**Champlain Hudson Power Express ("CHPE")
Environmental Management & Construction Plan
Notice of Major Change**

Project: Champlain Hudson Power Express

Notice Number: 318

Drawing References: Segment 10 (Package 6) Appendix C: Sheets C-127, C-128, C-414

C-127

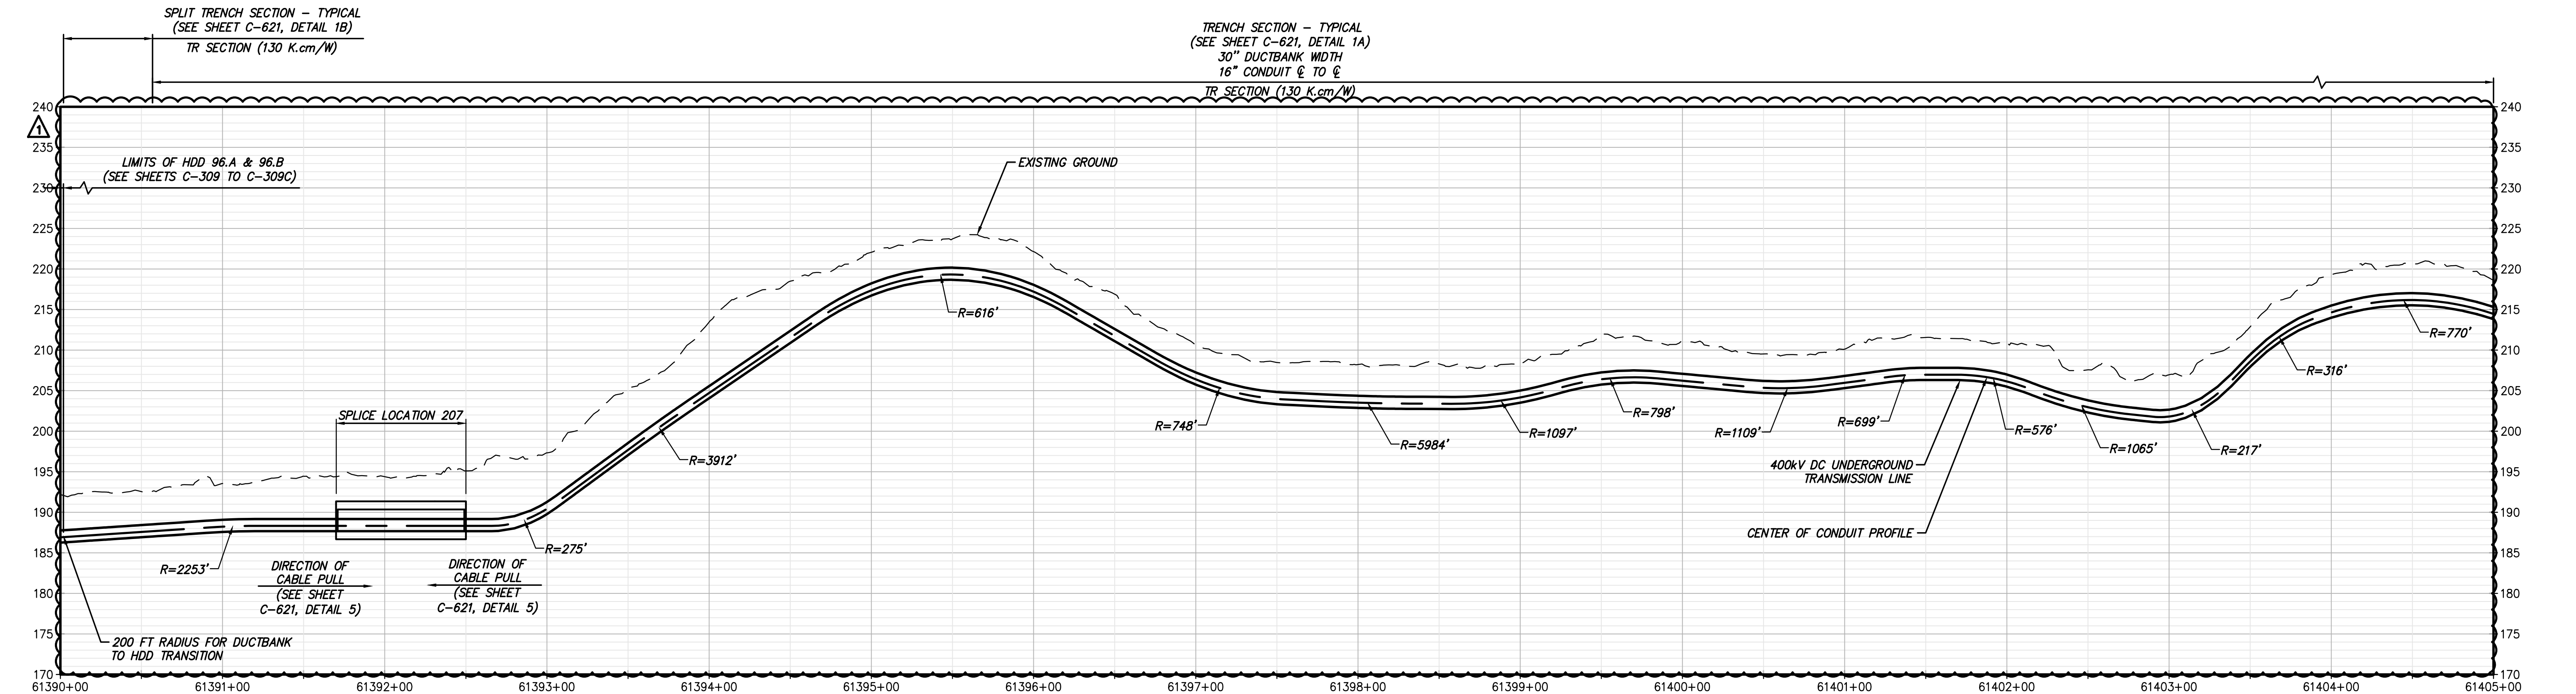
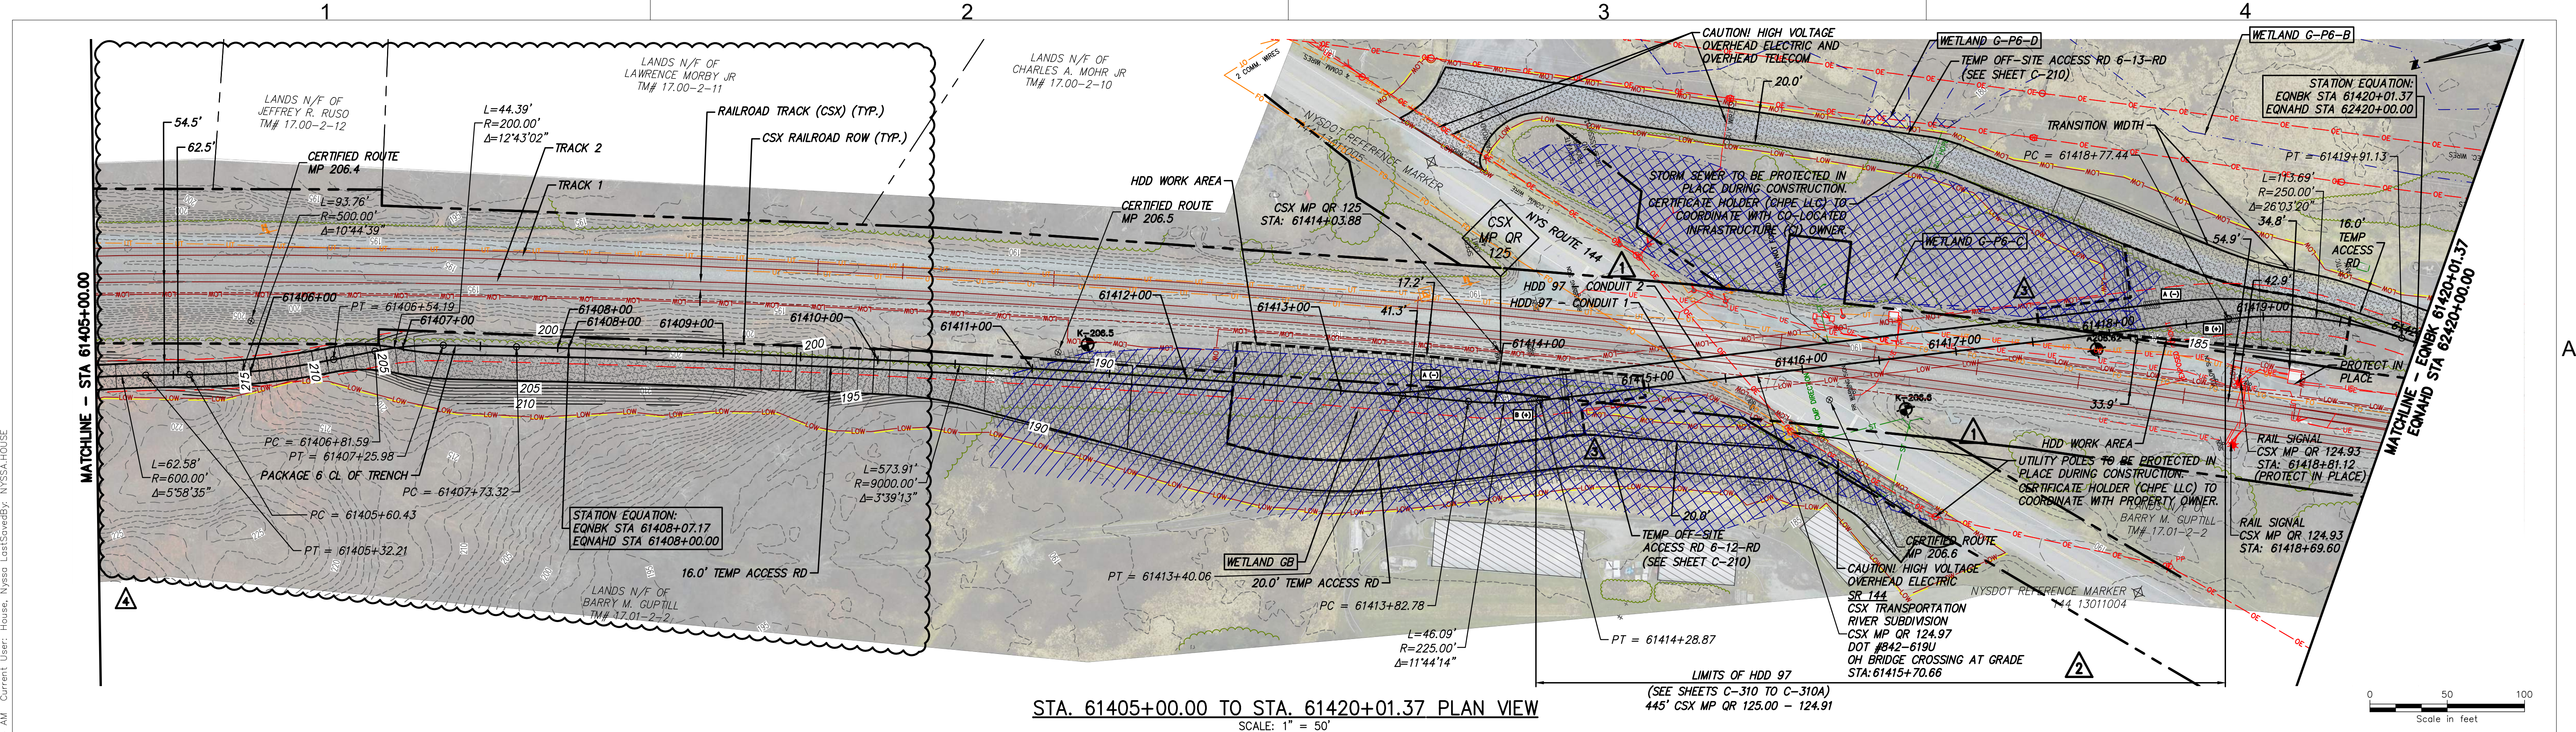
Sheet No.	Rev No.	Revision Description	Summary
C-127	1	FDC-0083: WP-208 Alignment & Access Revisions	- Converted Splice Location 207 (SL-207) to Typical Bathtub Vault and shifted ~10 feet ahead station (south) along the existing alignment from ~STA 61392+00 to ~STA 61392+10 to facilitate vault installation adjacent to existing utility infrastructure, per feedback from Kiewit operations team. Bathtub vault depiction captured in both plan and profile view. - Shifted alignment west from ~STA 61394+50 to ~STA 61405+00 to facilitate ductbank installation and minimize earthwork required for access. Revised vertical profile, grading, and access road design accordingly. Note that access revisions underneath overhead utilities at ~STA 61393+25 and ~STA 61394+40 ensure no build-up of proposed grade, and thus no reduction of existing overhead clearances. - Revised easement depiction to accommodate permanent alignment revisions. There are no changes to the approved limits of work (LOW) at these locations.

DRAWING NO.
C-128

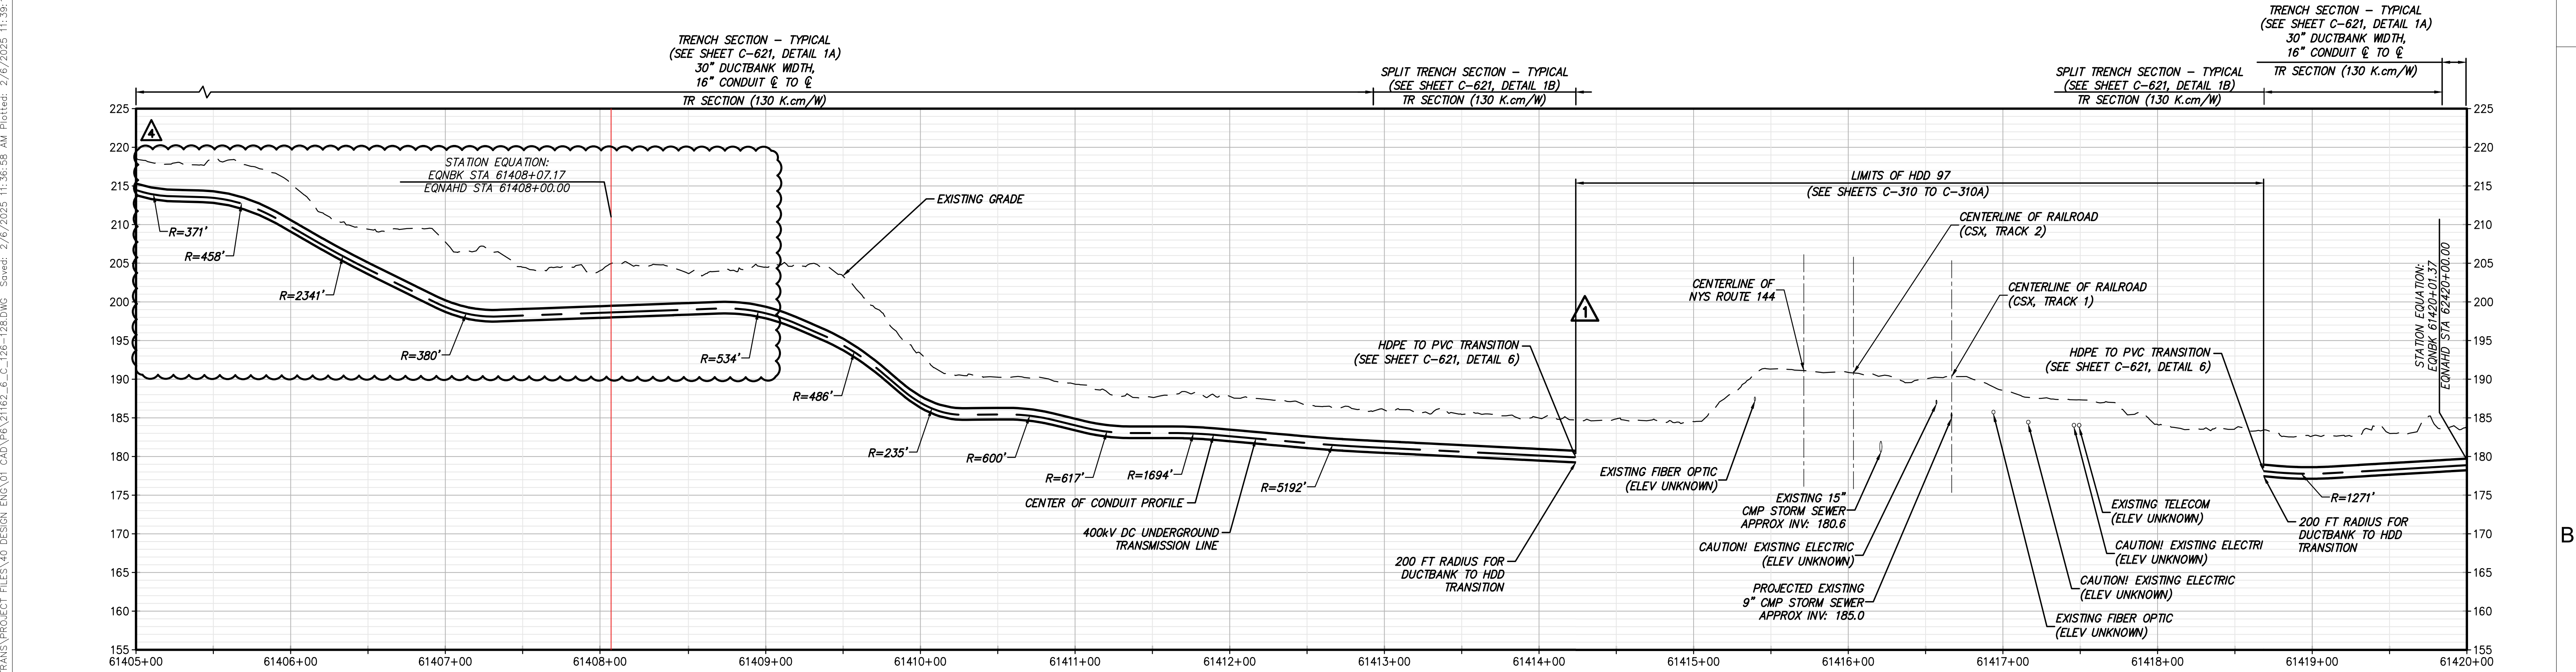
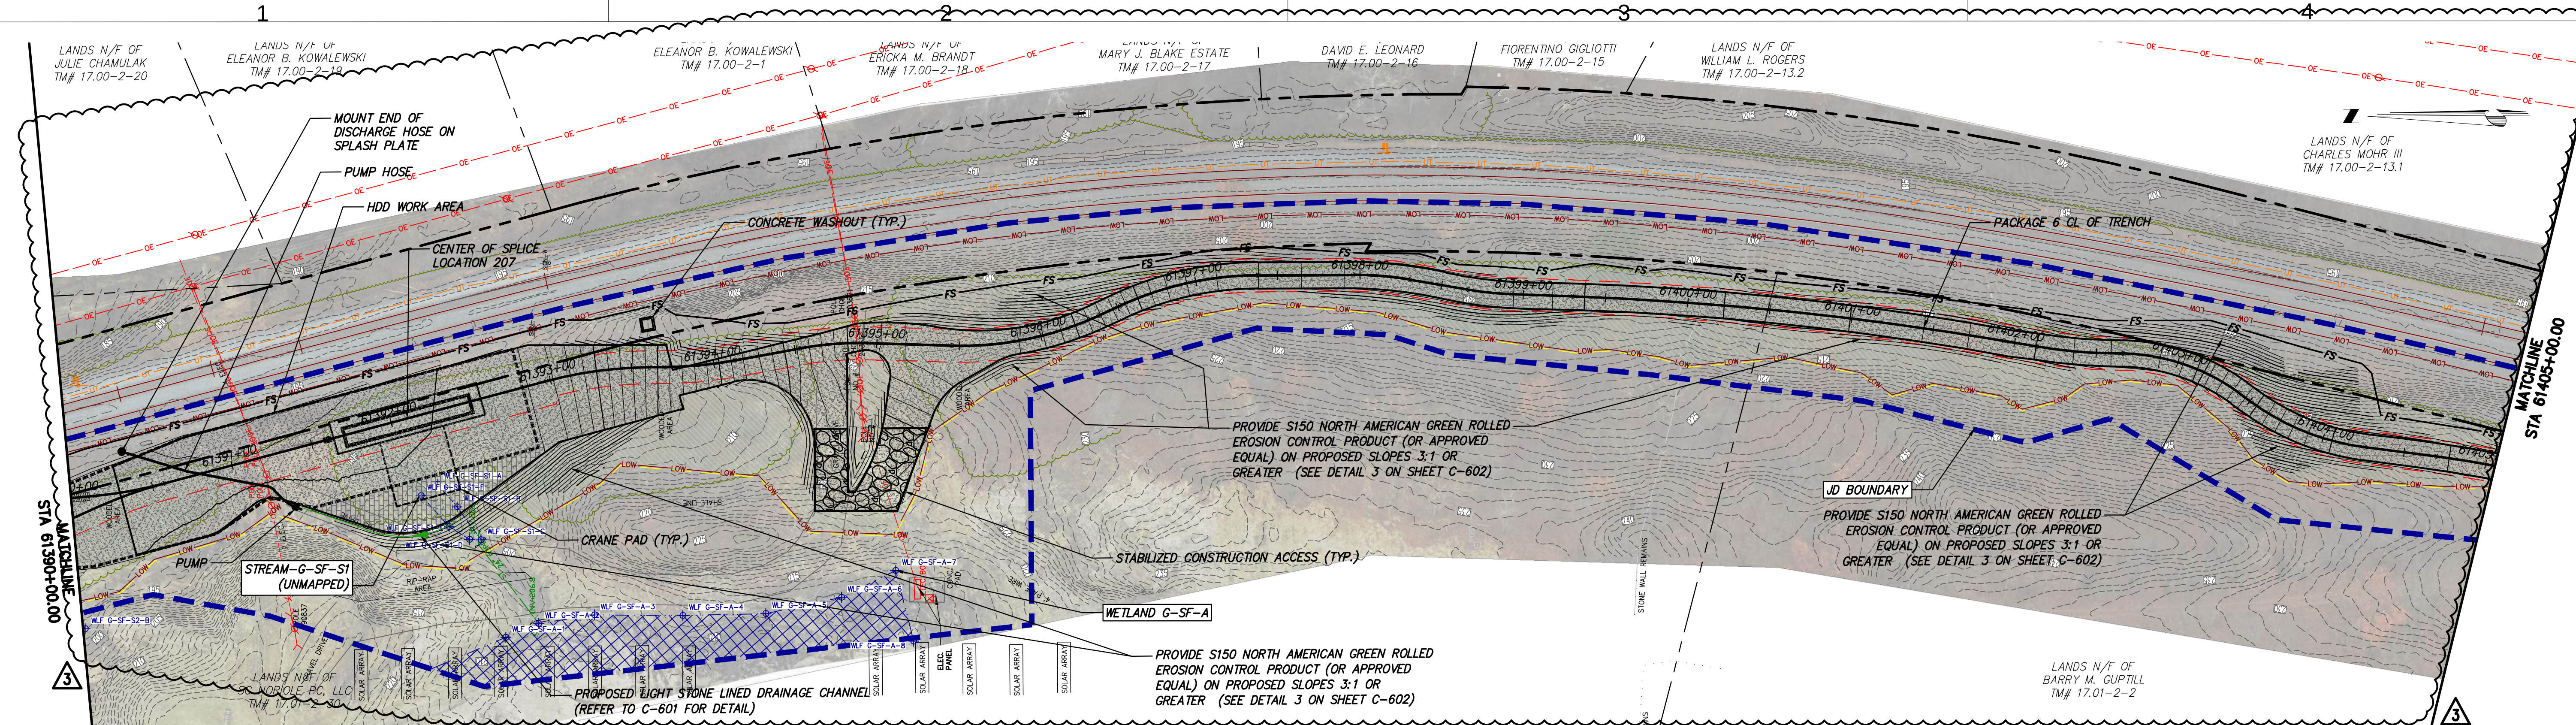
C-128	4	FDC-0083: WP-208 Alignment & Access Revisions	- Shifted alignment west from ~STA 61405+00 to ~STA 61407+10 to facilitate ductbank installation and minimize earthwork required for access. Revised alignment vertical profile, grading, and access road design accordingly. - Revised easement depiction to accommodate permanent alignment revisions. There are no changes to the approved limits of work (LOW) at these locations. - Added Station Equation 61408+07.17=61408+00.00 to plan and profile view.
C-414	3	FDC-0083: WP-208 Alignment & Access Revisions	- Sheet replot to capture permanent alignment, splice, and grading revisions from ~STA 61392+00 to ~STA 61407+00. Revised erosion and sediment (E&SC) controls accordingly. - Revised stabilized construction access design accordingly near ~STA 61395+00.
